AERONAUTICAL CHARTING MEETING
Instrument Procedures Group
Meeting 20-02 – October 27, 2020

RECOMMENDATION DOCUMENT

FAA Control #20-02-355

Subject: Minimum Enroute Altitudes (MEAs) Published on Standard Instrument Departures (SIDs) and Standard Terminal Arrivals (STARs)

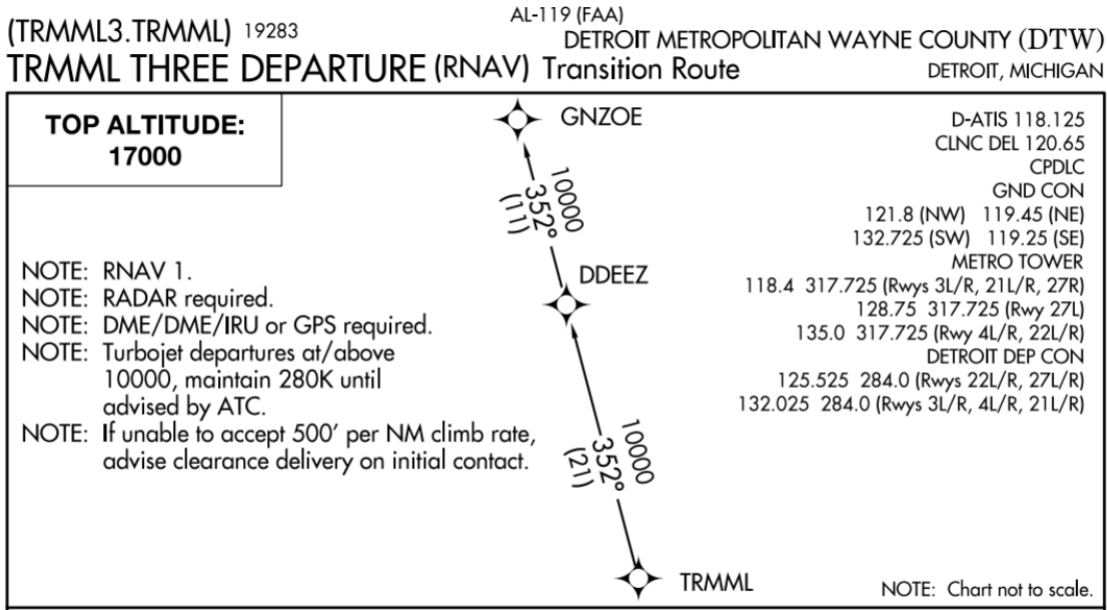
However, these changes to the 8260 Orders have failed to prevent the publication of ATC operational MEAs on SIDs and STARs. NBAA's research reveals that this failure is the direct result of conflicting guidance published in an Air Traffic Order used by the Flight Procedures Teams when assessing DME/DME coverage on SIDs and STARs that appears to be used in priority over the guidance furnished in the 8260 Orders.

Specifically, the conflicting guidance is found in the Air Traffic Order JO7470.1A, Distance Measuring Equipment (DME)/DME Infrastructure Evaluation for Area Navigation (RNAV) Routes and Procedures, in paragraph 10 b(2)(b)(i) and (ii):

(i) **For STAR** and en route procedures, input an altitude for each waypoint, route, or route segment. **Use the lowest realistic operational ATC altitude. The altitude evaluated at a waypoint will be charted as the minimum en route altitude (MEA) for the segment immediately preceding the waypoint,** and is entered as the MEA on the FAA Form 7400-4, STAR-Standard Terminal Arrival.

Unfortunately, the guidance provided above in this Air Traffic Order is resulting in higher than required MEA altitudes to support ATC purposes contrary to the 8260 guidance and expressed desires of the ACM. As result, we are still seeing higher than necessary MEAs being published on SIDs and STARs because of this conflict between FAA Orders. An example is shown below on this recently published SID at Detroit (DTW):

Amend Joint Order 7470.1A, Distance Measuring Equipment (DME)/DME Infrastructure Evaluation for Area Navigation (RNAV) Routes and Procedures to bring the MEA restrictions on SIDs and STARs in conformance with the guidance furnished in the applicable 8260 Orders.
